CITY OF HAYWARD AGENDA REPORT

SUBJECT: Zone Change No. PL-2004-0418 & Vesting Tentative Tract Map 7554/PL-2004-0417 –Arlene Utal for Chabot Estate Homes (Applicant)/ Greg Silva (Owner) – Request to Change the Zoning From a Single-Family Residential (RS) District to a Planned Development (PD) District and Subdivide 2 Acres to Build 11 New Homes and Renovate an Historic Home

The Project Location Is 2141 W. Jackson Street at the End of Cryer Street Near Chabot College.

TREES REMOVED:

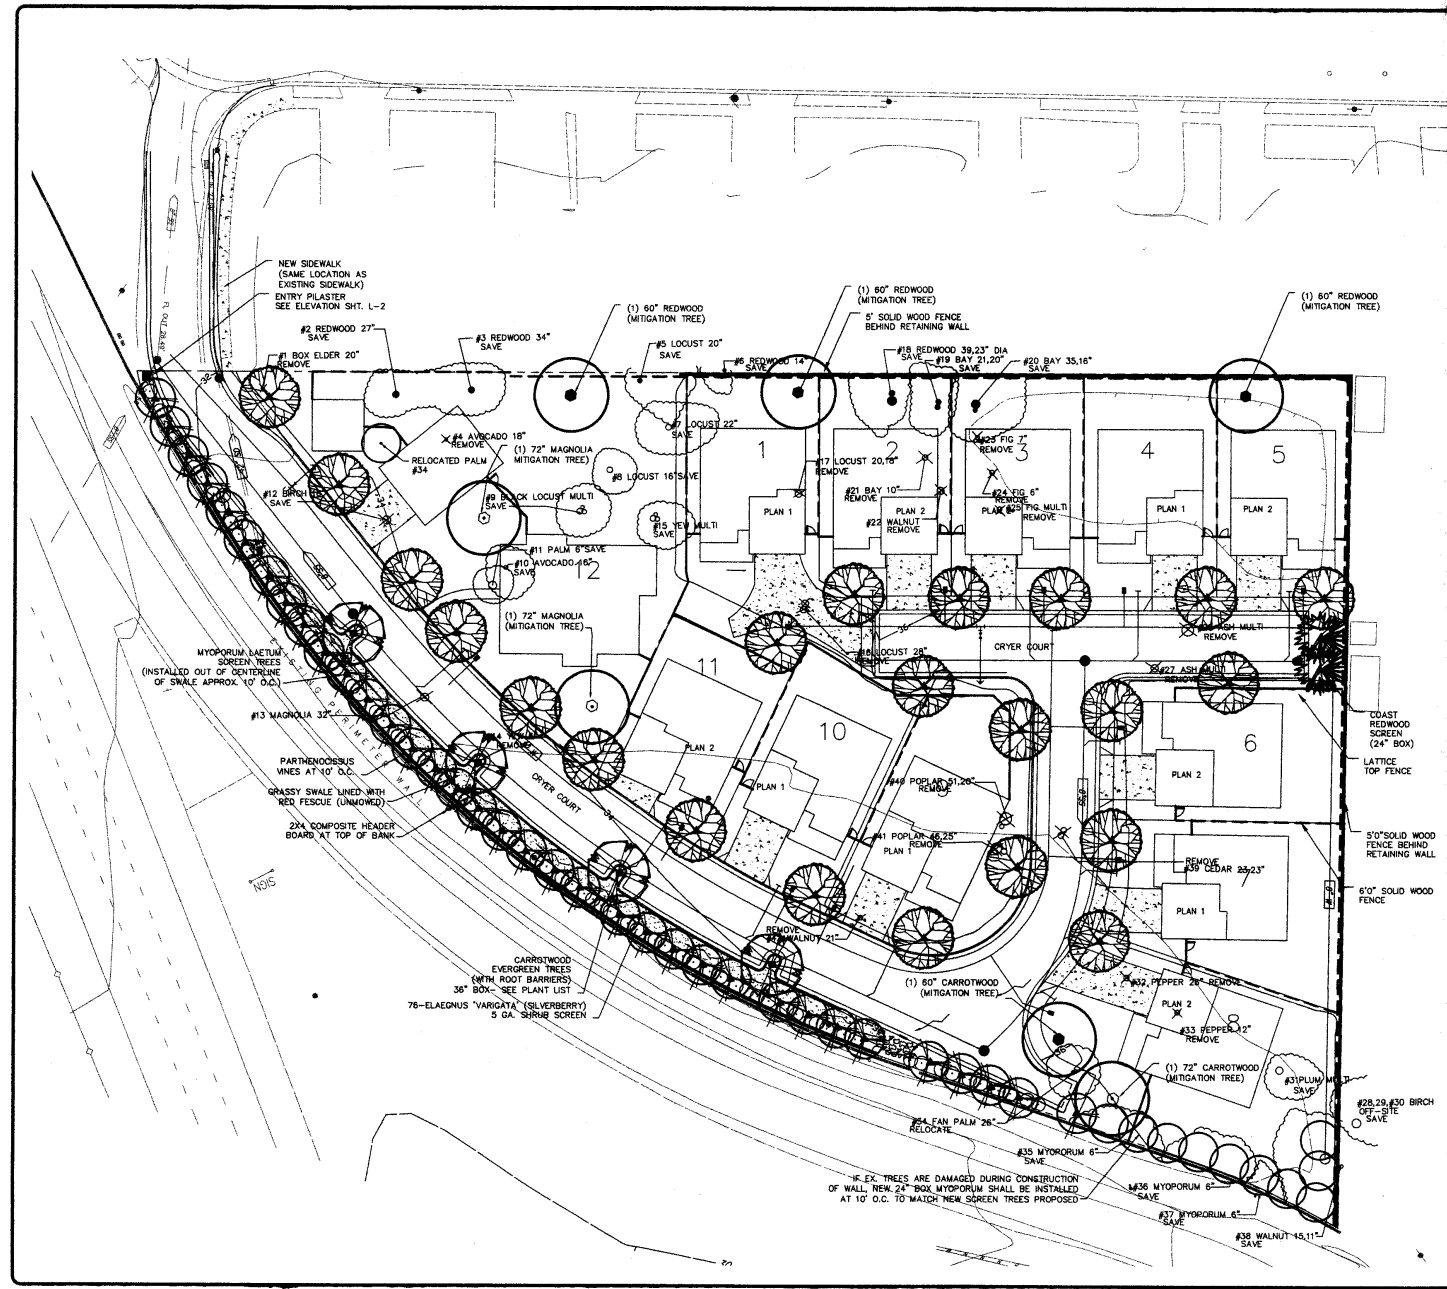
At the previous Planning Commission meeting, staff reported that trees 18, 19, and 20, as shown on the landscape plans, would need to be pruned to an unacceptable level to accommodate the houses planned for Lots 2 and 3. Commissioners asked for an attempt to provide better protection for these trees. After further review of the plans, the applicant's arborist determined that trees 18, 19, and 20, which are rated as being in good condition, would not survive the grading necessary for construction. The applicant now proposes to remove the trees and plant new trees of equal value. These trees, which have canopies that extend into lots on Adrian Avenue, are the three most valuable trees on the property. Given the number of trees required to be planted for this type of development, it is often difficult to find large enough trees or enough space to plant an additional number of trees for mitigation. In staff's opinion, the project should be designed around the trees. A City Design Guideline states, "Retain existing healthy, mature plant material as much as possible, especially large trees." To ensure proper protection of the trees, no grading or construction should occur within the driplines of the canopies of the trees.

22. It appears that some of the trees that are proposed to remain (#35, #36, #37, and #38) are in the way of proposed sound walls or fences. Show how this is proposed to be resolved.

Mylar copies of the approved plans shall be submitted with the mylars of the improvement plans.
19. Plans shall include a tree mitigation plan acceptable to the City Landscape Architect. Trees proposed for mitigation must be in addition to the required trees. The trees being proposed for mitigation must be equal in value to the trees that are being proposed for removal.

20. The planting plan submitted does not completely address the issue of the required trees for the site. Perimeter screening trees are not being shown in the correct amounts and there are not sufficient street trees being shown in required locations. Parking shade trees appear to be more than sufficient. The required trees must be shown in addition to the proposed mitigation trees.
